SEWAGE DISPOSAL SYSTEM

MARYLAND STATE DEPARTMENT OF HEALTH

SUBDIVISION Kephins Mead

ON-SITE SEWAGE DISPOSAL SYSTEM HOWARD COUNTY HEALTH DEPARTMENT BUREAU OF ENVIRONMENTAL HEALTH

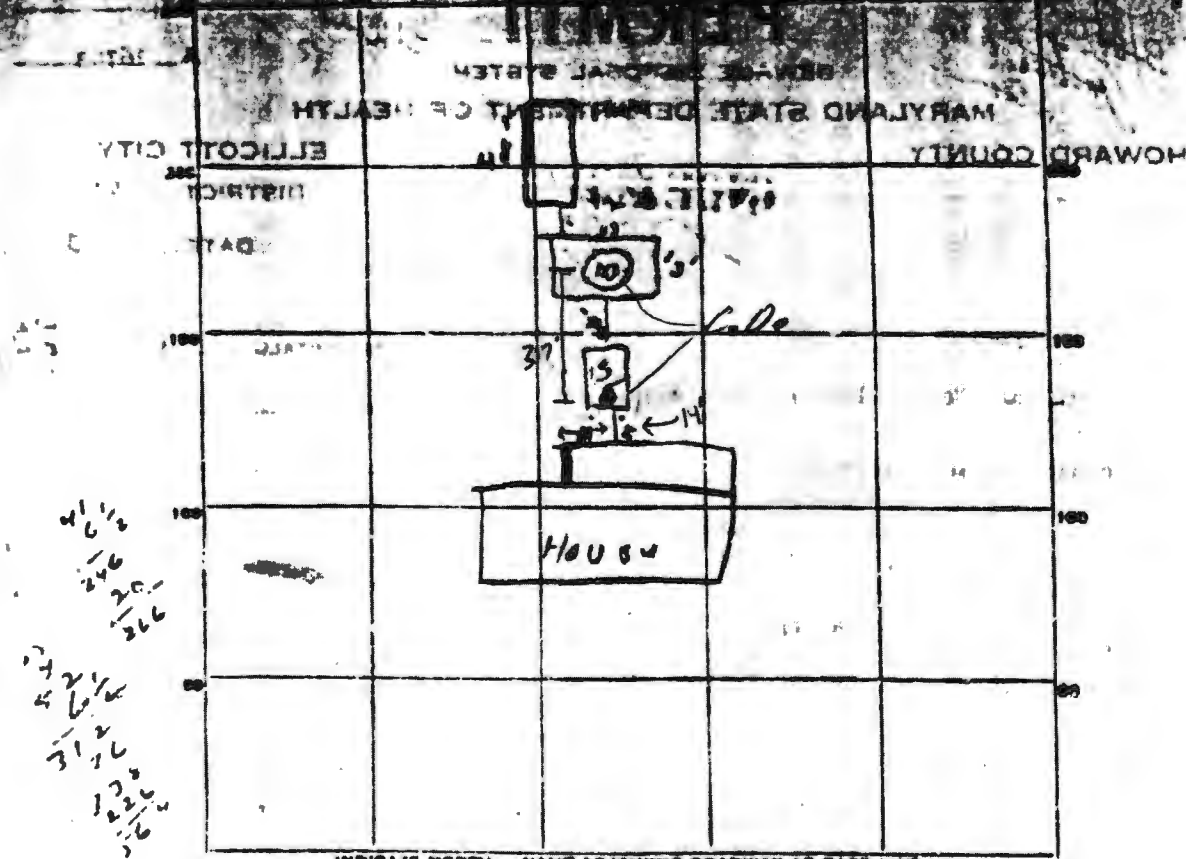
OK to change DW location to location shown on sketch - 700 sq ft trench - 12' deep - 40' long

PLOT PLAN 7416 CHERRY TREE DRIVE 5TH ELECTION DISTRICT HOWARD COUNTY, MARYLAND	SCALE : 1" = 50'
	DATE : March 20, 2002
	DRAWN BY : PCG
LOT 3, SECTION 5, "HOPKINS MEADE", MARYLAND	PLAT 22, FOLIO 99
OWNERS : SANDOR AND KAVITA MESTER

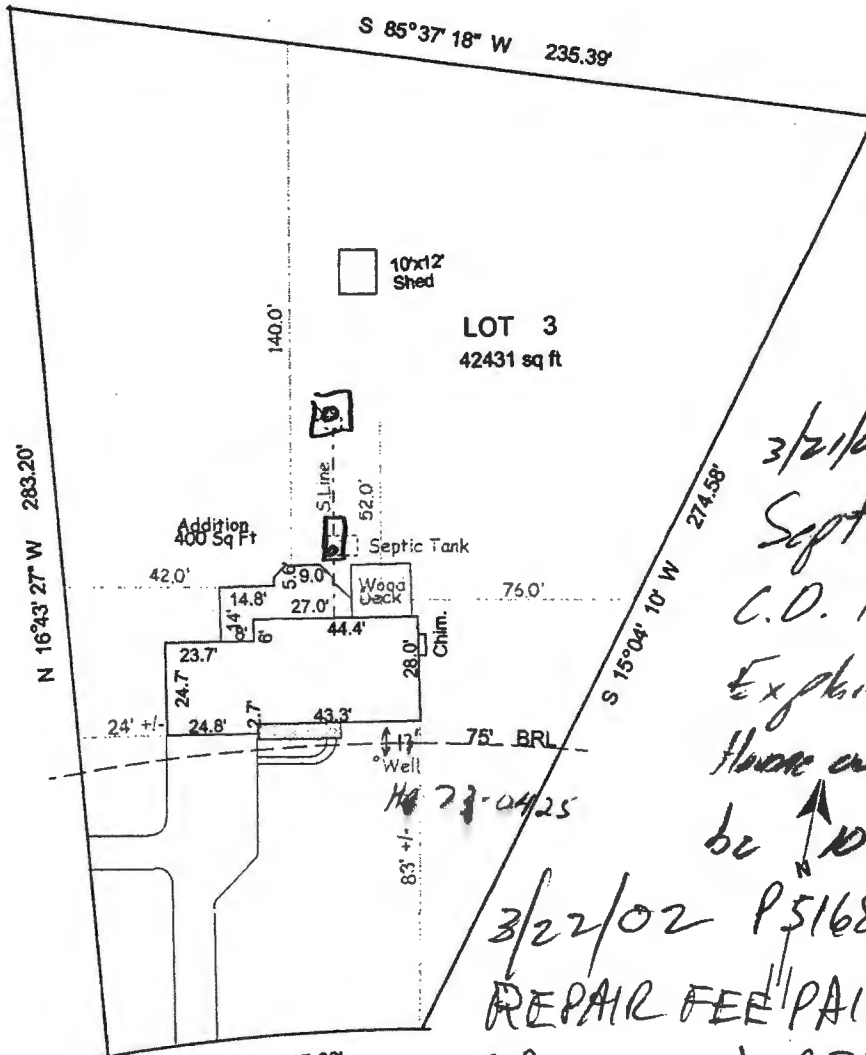
3/21/02 (SC)
 Septic DK
 C.O. 15' from house
 Explained to
 Home owner tank must
 be 10' from house

3/22/02 P516879 \$25
 REPAIR FEE PAID
 BP ISSUED, REPAIR EXPECTED
 IN 1-2 WKS (MR)

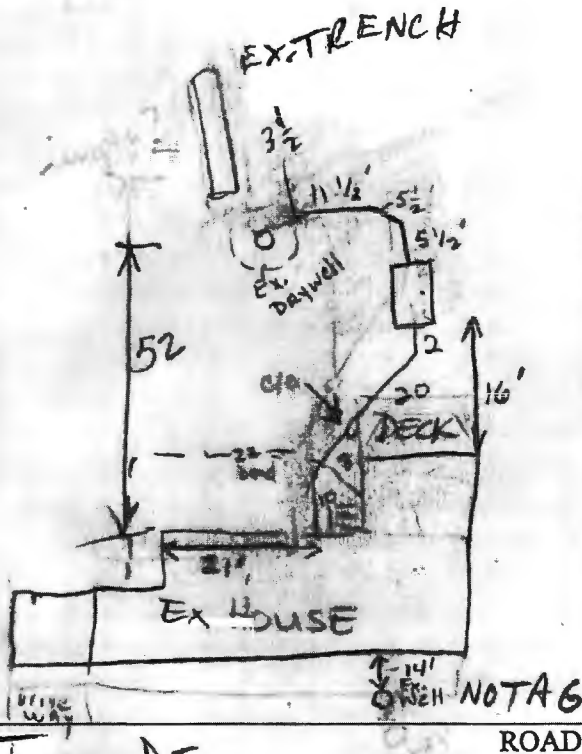
INSTALLATION 4/5/02 New S.T. installed. OK. Existing drainfield eval. top of trench dry & around drywell. Inlet to d.w. @ 6'. MR/KG
